CITY OF ALBUQUERQUE

**RE: Tract H Sawmill
1921 Bellamah Ave NW
Conceptual Grading and Drainage Plan
Engineer's Stamp Date: 7/6/2022
Hydrology File: J13D017B**

Based upon the information provided in your submittal received 8/17/2022, the Conceptual Grading and Drainage Plan is approved for Site Plan for Building Permit and DRB approval. Prior to submitting for construction and building permit please address the following comments prior to submitting.

ENGINEER'S SEAL	1921 BELLAMAH AVE NW ALBUQUERQUE, NM	DRAWN BY pm
		CONCEPTUAL GRADING PLAN	DATE 7-6-22
			DRAWING
			SHEET # GR-1
RONALD R. BOHANNAN P.E. #7868		JOB # 2022047

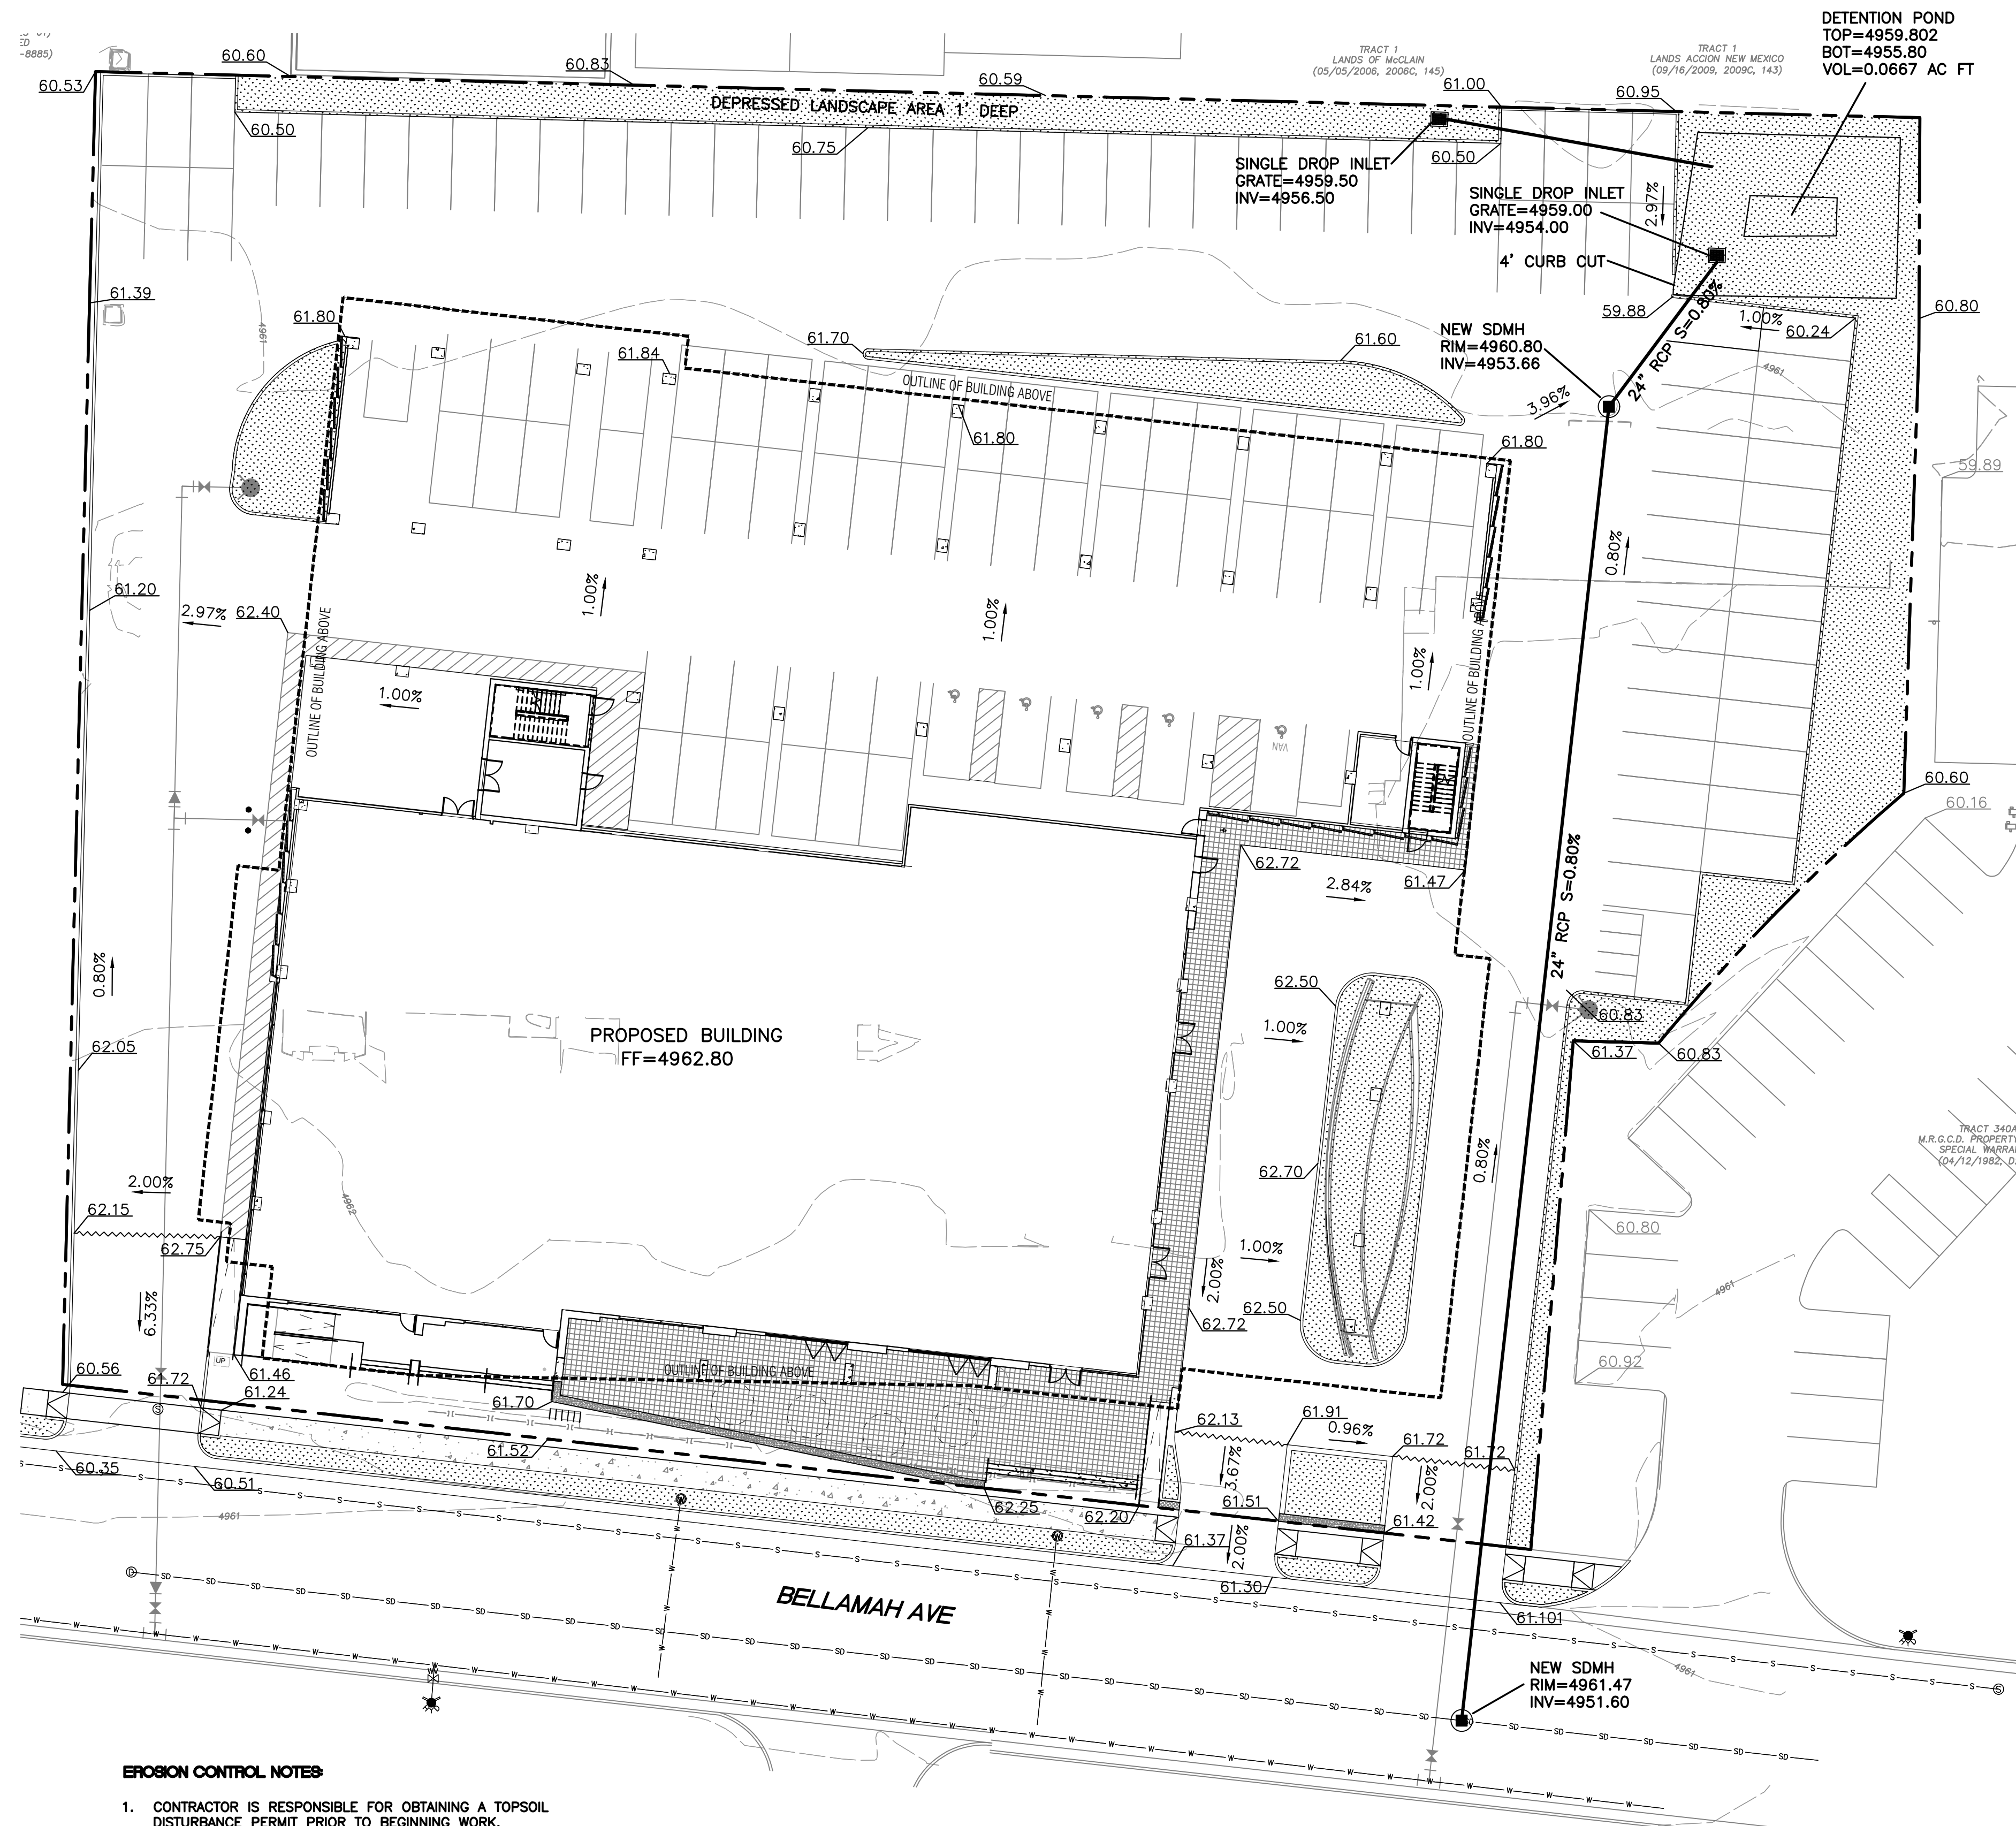
1. Add adjacent grades to show what the site is tying into.
2. Clarify the curb and gutter around the site so that it is called out and it is visible to see the lines shown on the legend.
3. The narrative calls out some things to be demolished. Please provide this information on future submittals so that it matches the narrative and it is clear what is being removed.
